Amendment of the MASS - DER

Evergen response to draft report and
determination

August 2021

Fig. 1. Range of sampled FCAS responses resulting from possible t_0 -estimate errors using AEMO's current "relative window" approach. Errors skew towards t_0 -estimate being later than t_0 -actual, and an overestimate of FCAS delivery.

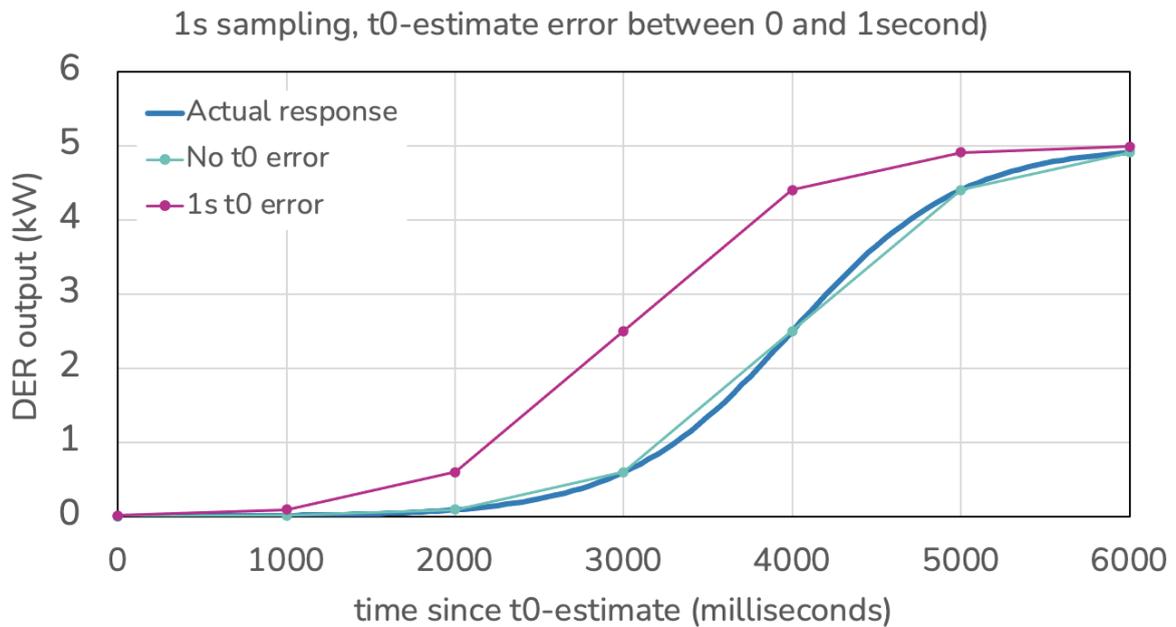
AEMO's approach to estimating frequency disturbance time (we will refer to an estimate as *t0-estimate*) is to use the timestamp of the first sample where frequency falls *outside* of the NOFB as *t0-estimate*. This means that *t0-estimate* will *always* be some time *after* *t0-actual*.

This approach is named the 'relative window approach' by Mancarella et al., (2021). With this approach, the error in *t0-estimate* will not be uniformly distributed around zero across the devices comprising a DUID, it will include a bias, and a subsequent bias in estimation of FCAS delivered energy.

As shown in the Melbourne University study, the relative window approach results in FCAS energy delivery being biased towards *overestimation*.

This systemic bias towards over-estimation of FCAS delivery is larger for coarser sampling rates. For 1-second sampling for verification, the error in *t0-estimate* could be as much as 1 second after the battery commences its response (or close to zero seconds if a sample occurs a very short duration after *t0-actual*).

This range of errors is depicted in Fig. 1 below. A sampled FCAS response might occur anywhere between the two depicted edge cases - always resulting in an over-estimate of FCAS delivered energy (the area under the curve over the assessable 6-second period).

Fig. 3. Simulated raise response of a single 5kW DER, with and without oscillatory noise. The noise is a superimposed sine wave with 3Hz frequency and amplitude of 30% of 5kW.

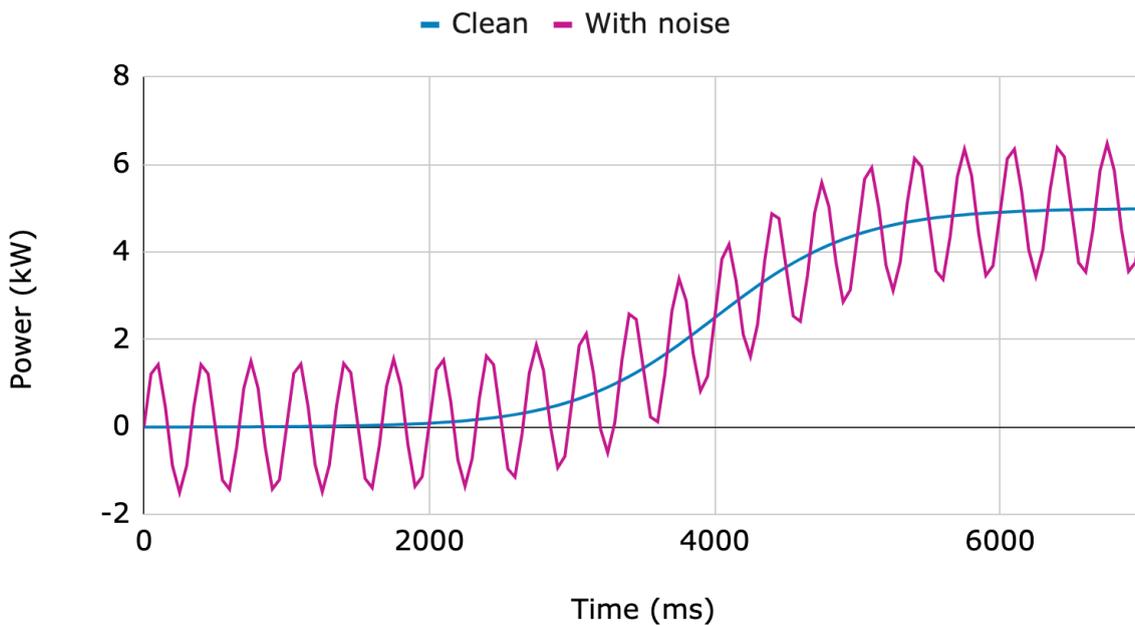
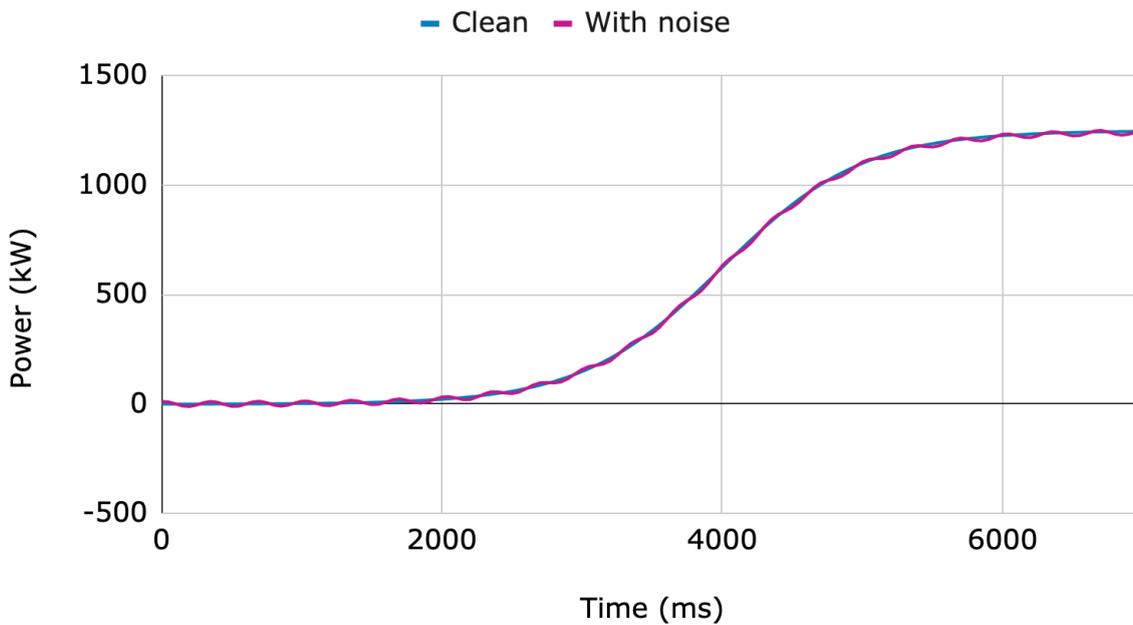
AEMO sought advice from the University of Melbourne on the impact of an oscillatory response at the fleet level (an oscillation with a huge magnitude of 30%, or 1.5MW for the 5MW fleet considered!). Mancarella et al. state that they included this case as a 'stress test' of the different integration methods (trapezoidal, Riemann sums etc). However, they also suggest that this response pattern "...might be seen in less diverse aggregates of inverter-based providers", (Mancarella et al., 2021, p. 10 footnote).

This is misleading, because 'less diverse' is an understatement. It is implausible that a VPP would consist of a majority of devices that each failed in the same way such that the fleet aggregate would see such a significant oscillation. The faulty inverters would need to be identical in their failure, and in their response and oscillations at each time point. This is not 'less diverse', it is 'perfectly uniform'.

Figs. 3 and 4 show an example of how, even for an extreme edge case of a VPP consisting of 250x5kW DERs, where **every** DER suffers the same oscillatory response, would not result in a significant impact to the aggregated fleet response if all the oscillatory noise waves for each DER were not perfectly in phase. In the

As can be seen in Fig.4, individual oscillatory responses destructively interfere with one another to dampen the possible oscillation at the fleet level when not *perfectly* aligned.

Fig. 6. Distribution of error percentage across 1000 different 1s sampling series, using AEMO's current method for determining t_0 -estimate.

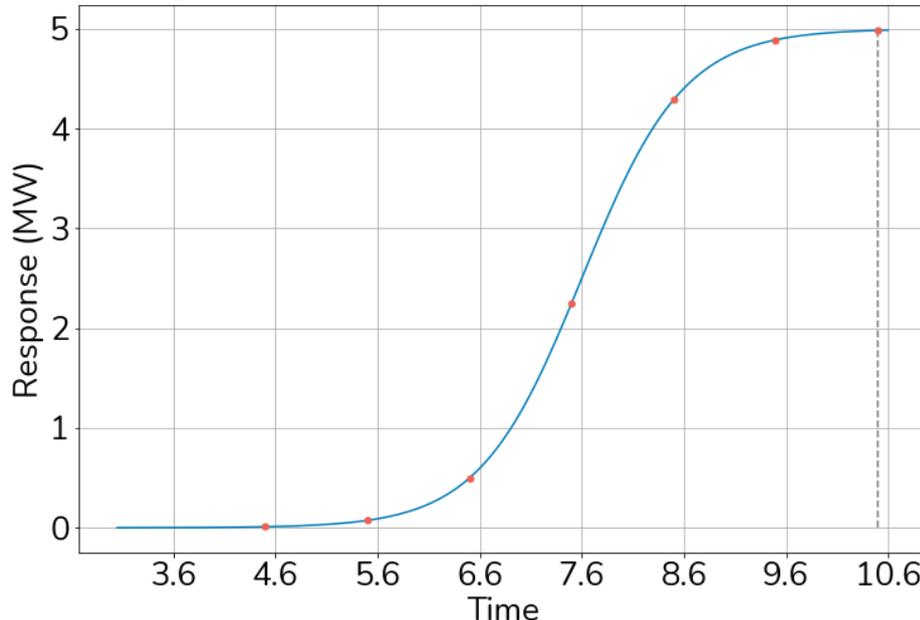
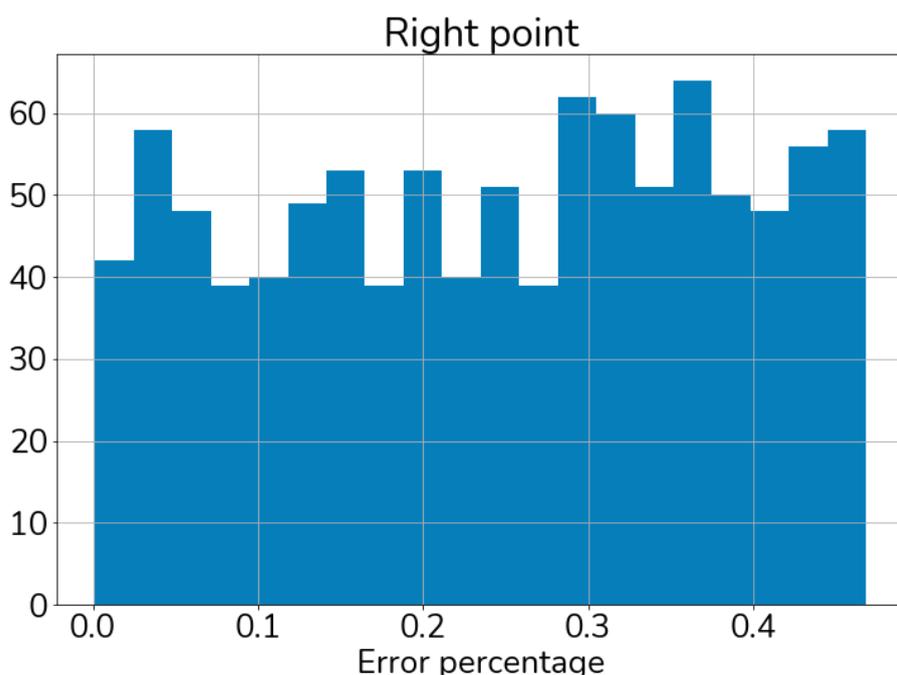
AEMO's current methodology is to take the timestamp of the first recorded sample after frequency leaves the normal operating frequency band (NOFB) as t_0 -estimate, and uses this as the start of the 6s assessment window. For example, if the actual frequency disturbance time (t_0 -actual) is at 3.6s and the first recorded sample is at 4.5s (t_0 -estimate), then the true 6-second window is between 3.6s and 9.6s while the assessed window will be between 4.5s and 10.5s, as shown in Fig. 5.

The selection of k is repeated 1000 times. Fig. 6 shows the error percentage compared with the true value (the area under the curve between 3.6s and 9.6s). It is approximately uniformly distributed, and it supports the Mancarella et al. finding that the current assessment method *always* overestimates the assessed FCAS delivery.

Fig. 8: Distribution of error percentage using new approach to t_0 estimation

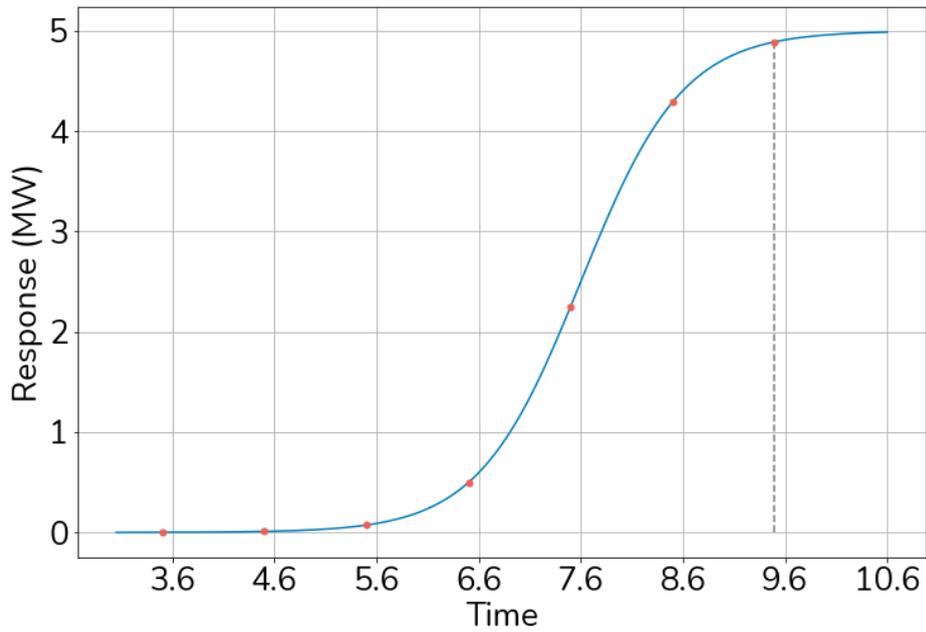
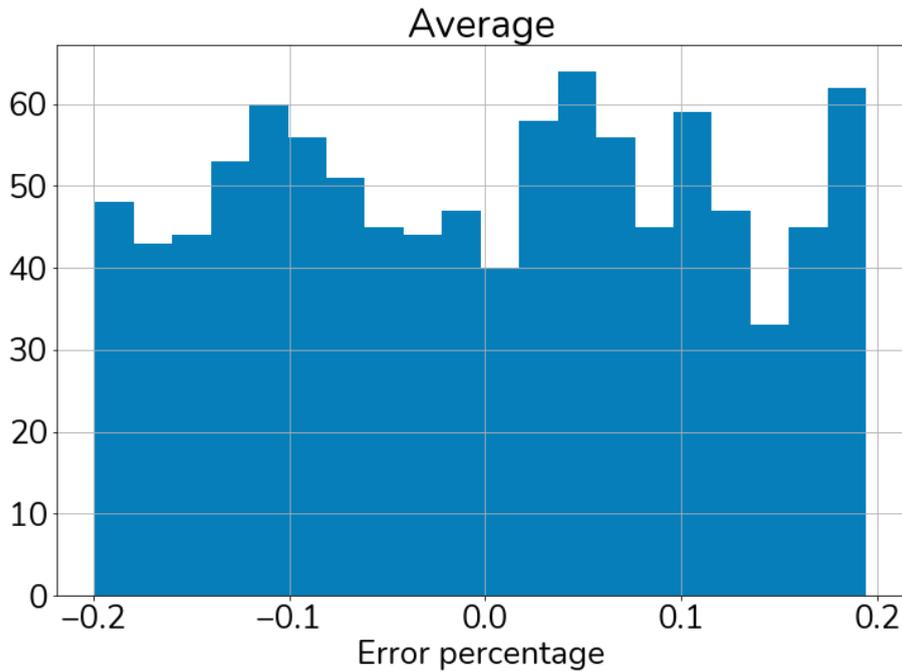
If Instead of choosing the first point *after* the frequency leaves the NOFB, we were to use the timestamp of the last point *before* the frequency leaves the NOFB as t_0 -estimate, then the calculated delivered energy would instead be *always* underestimated.

If we were to average these two estimates, the resulting error may be an overestimate or an underestimate, instead of always one or the other.

Evergen also calculated the error of the average of these two estimation methods for 1000 simulations using a similar method to that discussed above. The new distribution of percentage errors is shown in Fig. 8. It is also approximately uniformly distributed, but is now centred (x axis) on a mean error of approximately 0.
